Hawley Wharf Area D

Non-material Amendments Application - R023

Report title: Building D

Non-material amendments

4.2 Revised Scheme

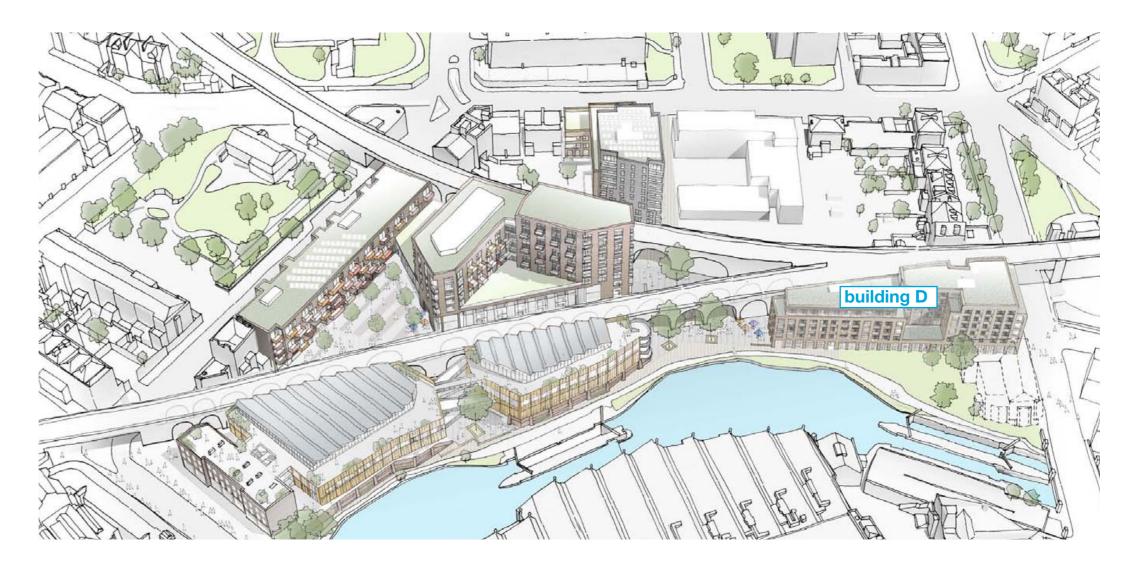
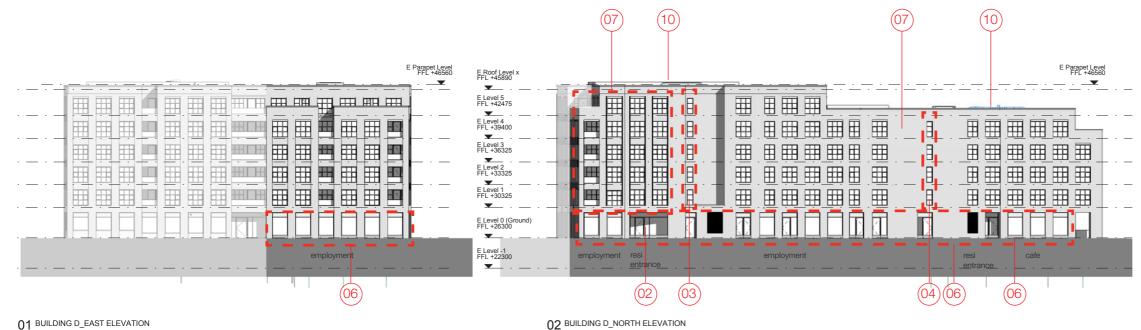
- Central rooflight raised to form 1100mm perimeter fall protection & delineate roof terraces.
- Recessed residential entrance opening enlarged central pier removed
- Windows added back into stairwell as per the original permitted planning approval.
- Windows to stairwell reduced in width to match stairwell further along Water Lane.
- Ground floor windows adjusted to large format single pane units with cills raised to 400mm above internal finished level.
- 7 Brick detail simplification Water Lane
 - Infills omitted except first 4no bays from Kentish Town Rd.
 - Bullnose brick to entire opening to all windows from stair core onwards
- Brick detail simplification Courtyard
 - Omit infills
 - Staggered brick detail applied to complete elevation
- (10) NEW Smoke vent./extract plant on roof.

4.4 Revised Scheme - Basement Plan

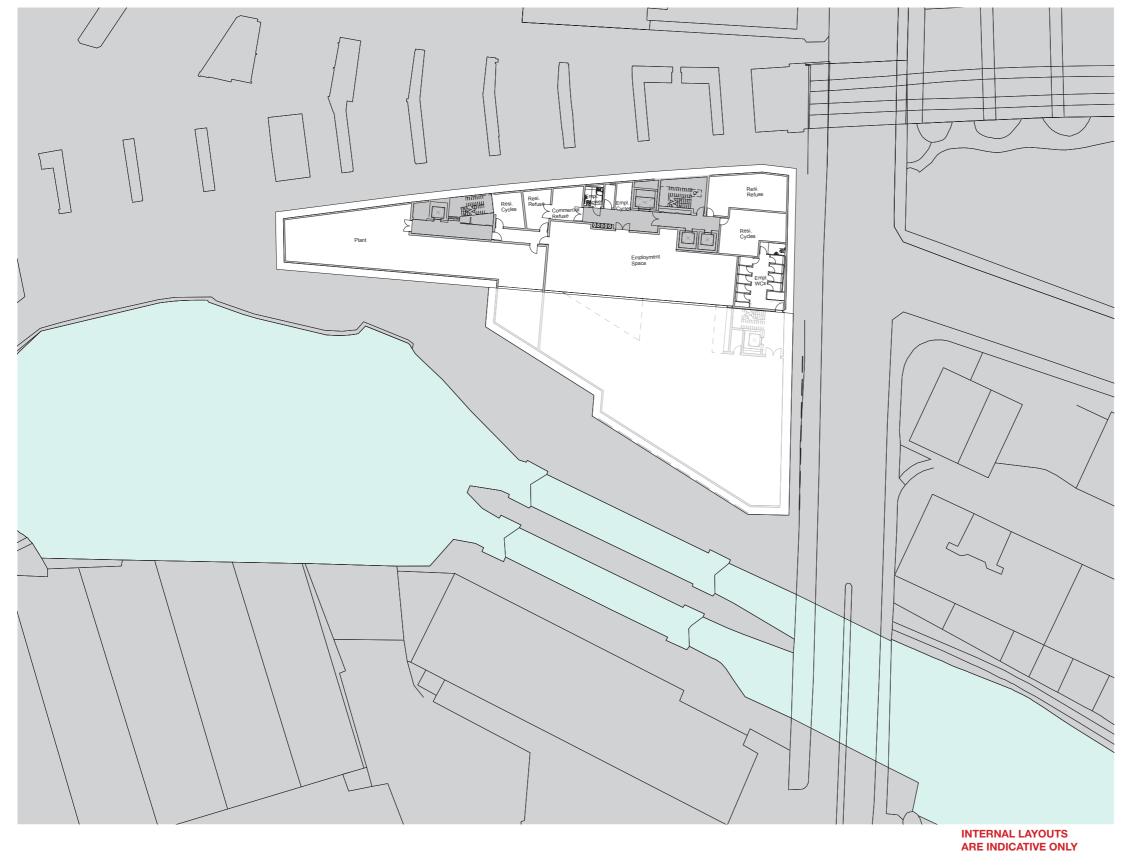
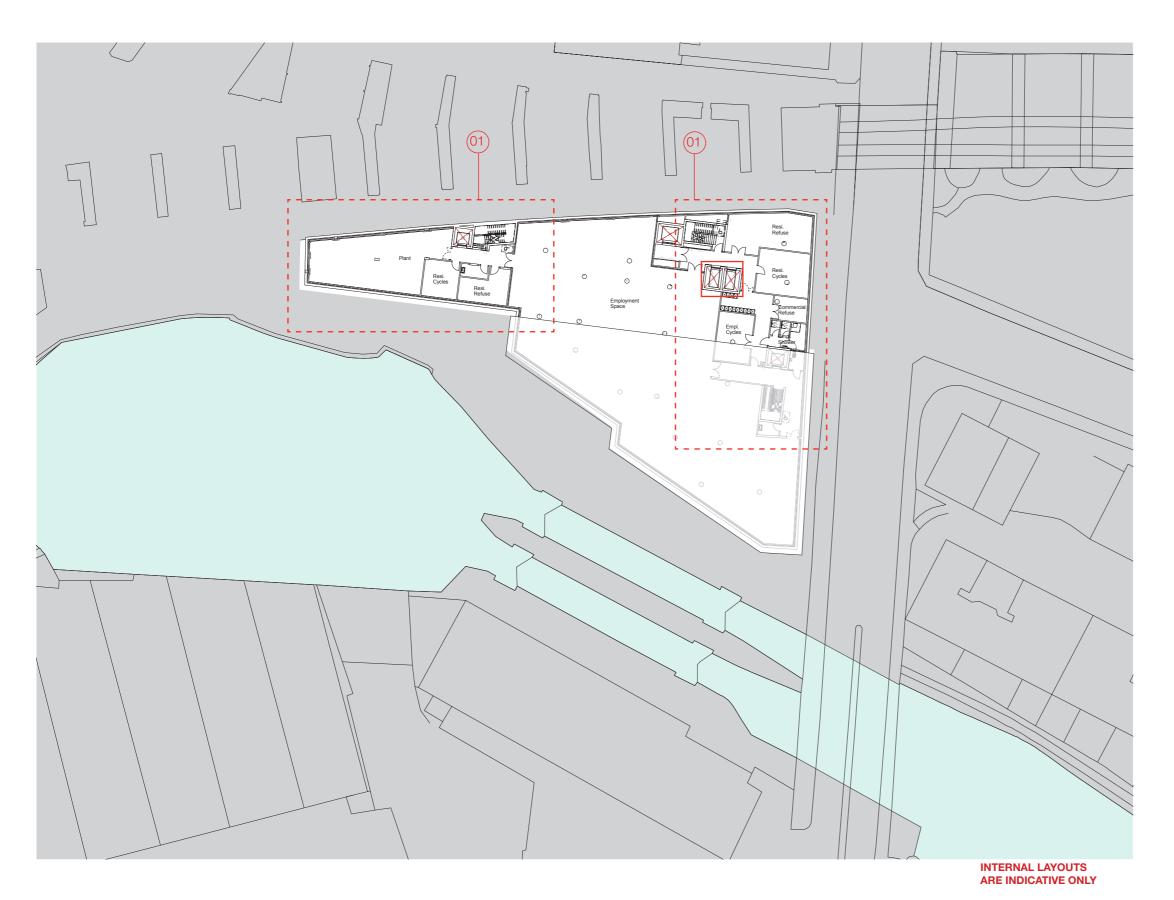
General layout changes.

4.6 Revised Scheme - Ground Floor Plan

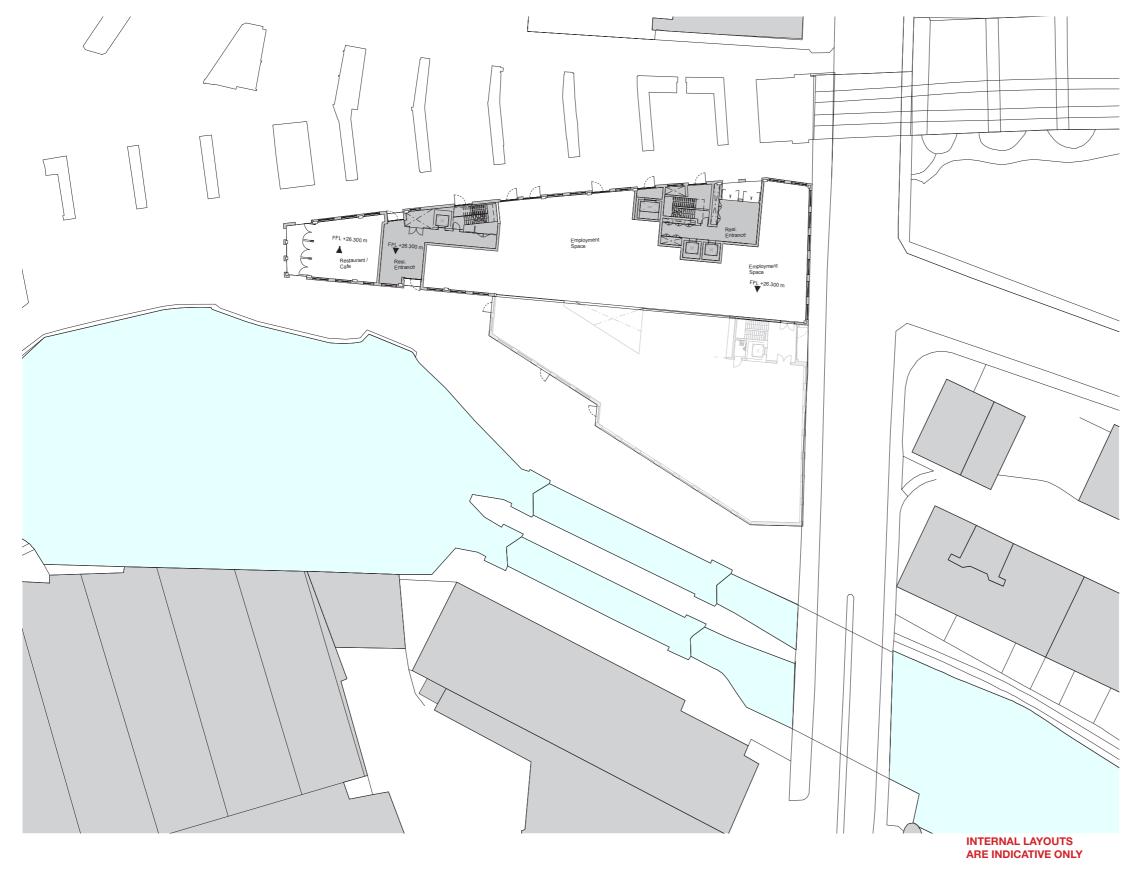
Residential entrances enlarged.

Doors simplified for clarity of entrance.

4.8 Revised Scheme - Fifth Floor Plan

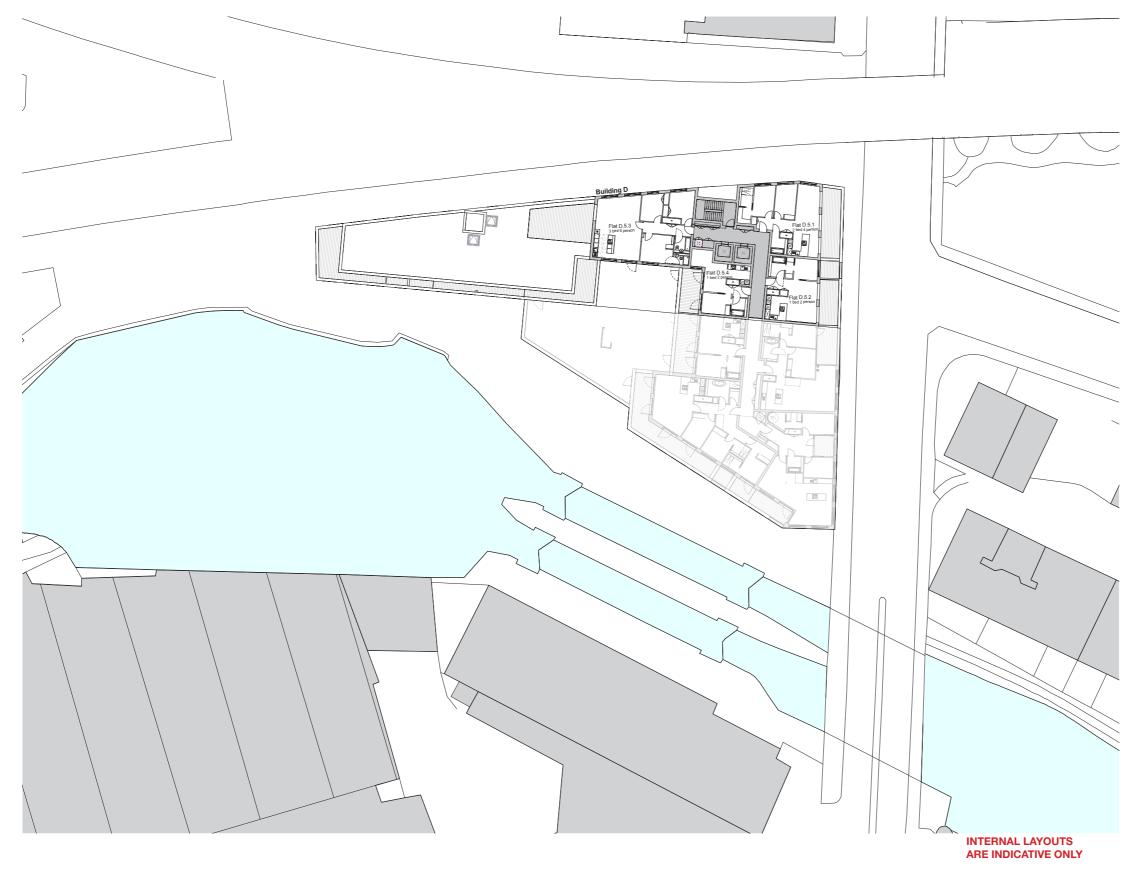
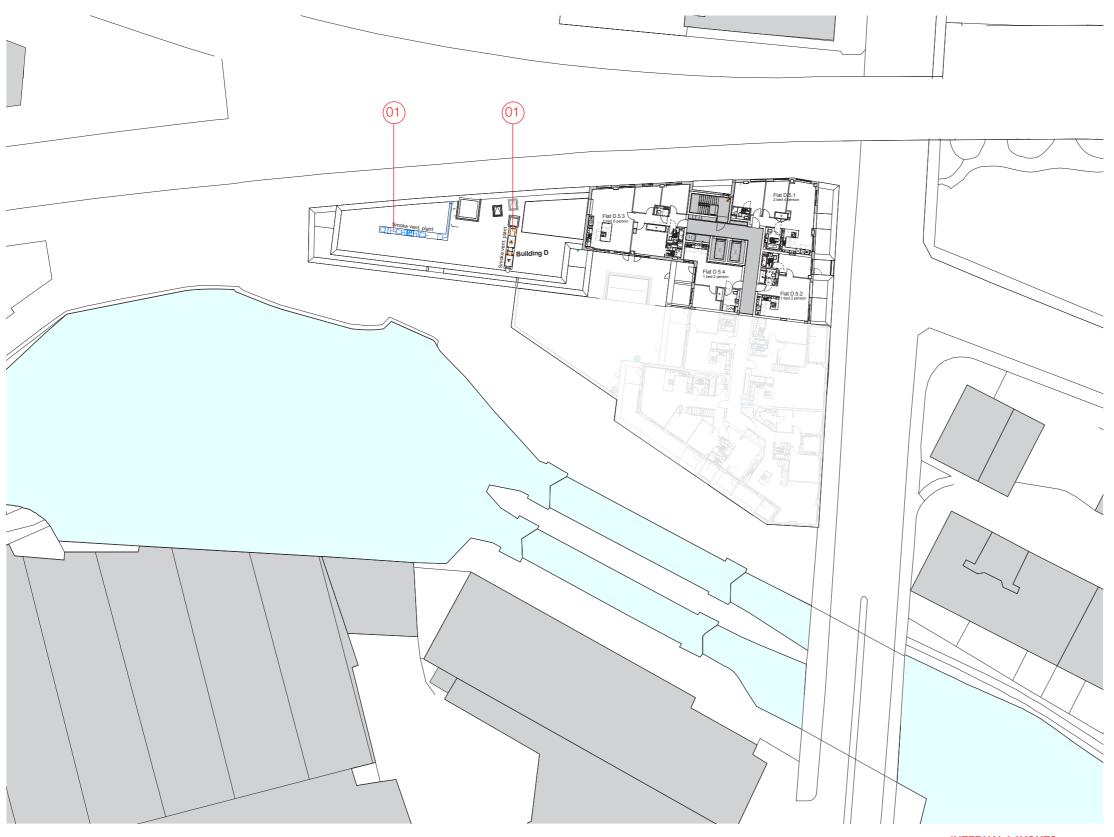
New smoke vent./extract plant on roof.

4.10 Revised Scheme - Roof Plan

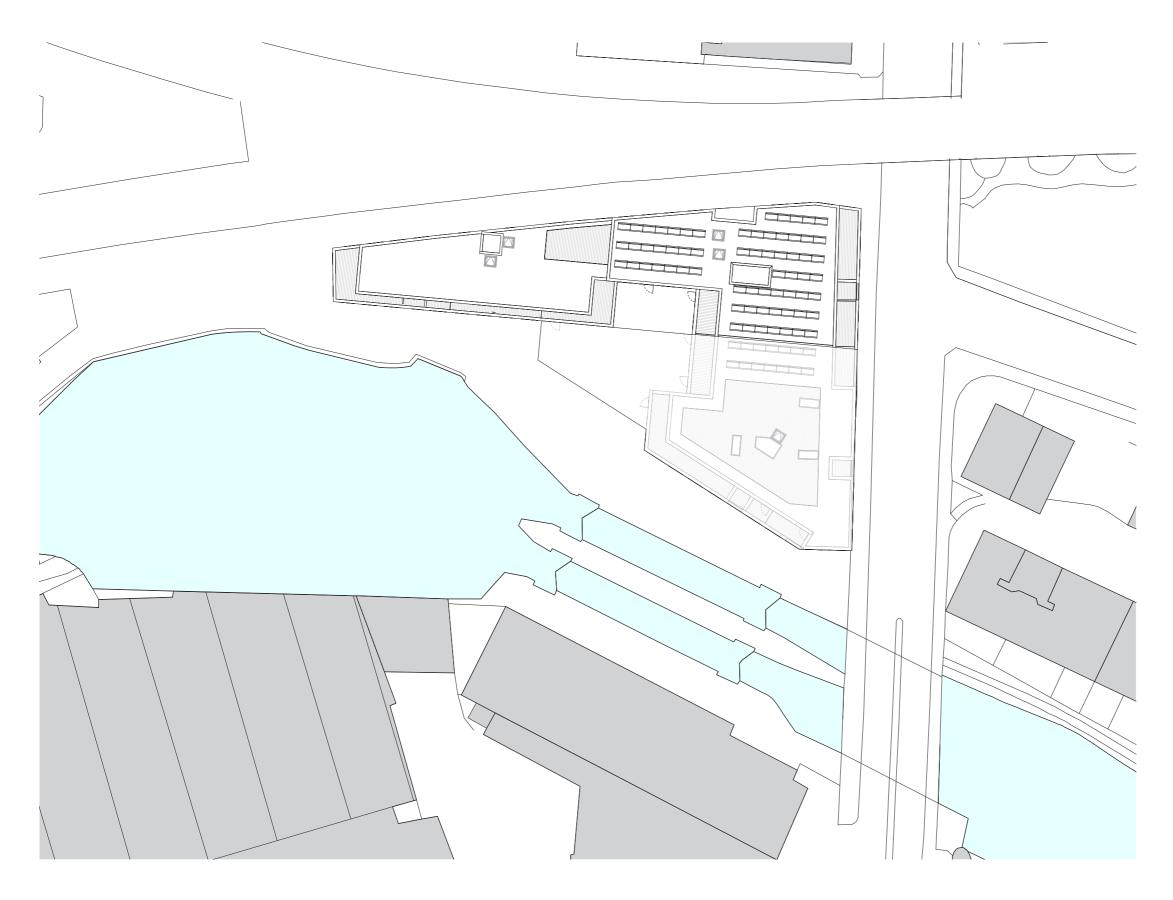
New smoke vent./extract plant on roof.
